Intel[®] Pentium[®] III Xeon[™] Processor Specification Update

Release Date: May 2002

Order Number: 244460-035

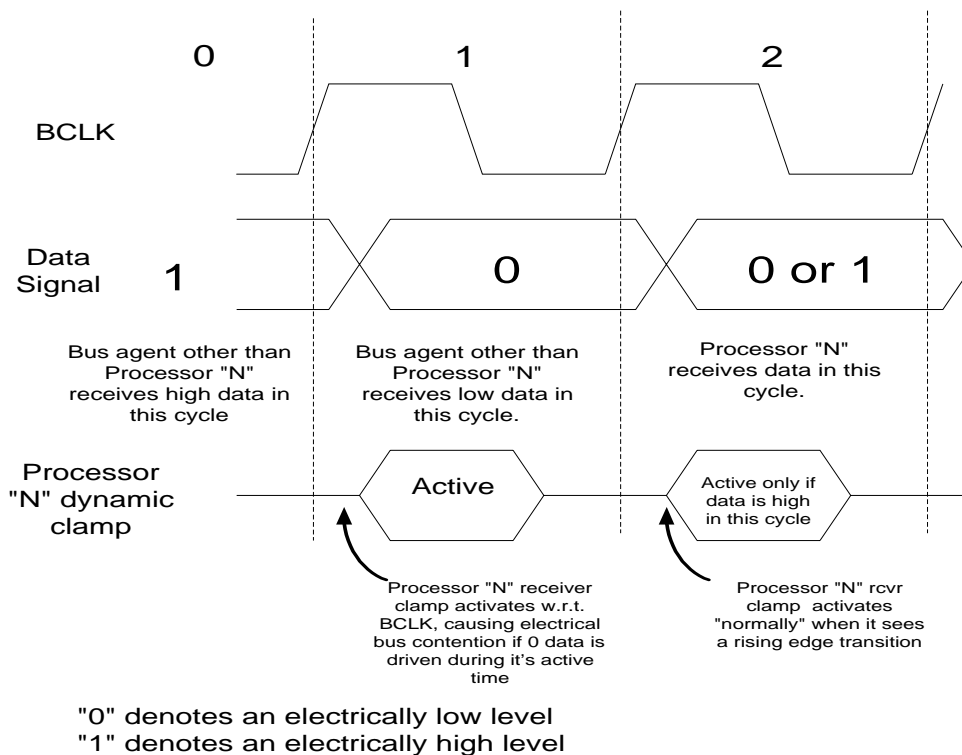
Workaround: The AGTL+ V_{REF} (input voltage reference) level will be raised from 1.0V to 1.1V (assuming a V_{TT} of 1.5V) on the processor cartridge substrate. This allows the dynamic clamp to activate at a trigger level approximately 100 mV higher than with the previous 1.0V V_{REF} setting. Due to the dependence upon system bus design, bus layout may be evaluated to determine the need for improvements in falling edge ringback levels. This may involve one or several of the following baseboard modifications:

1. Change termination resistor value to reduce multi-bit noise and/or improve V_{IL} noise margin.
2. Reduce multi-bit noise by improving ground return paths (additional high-frequency decoupling, improved AC plane referencing, etc.).
3. Raising or lowering the V_{TT} level (within the AC & DC tolerances specified in the processor EMTS) to improve V_{IL} noise margin and/or reduce the multi-bit noise due to dl/dt transients.

Stress tests using various data patterns and transactions should be run to identify the worst-case multi-bit noise conditions for this erratum.
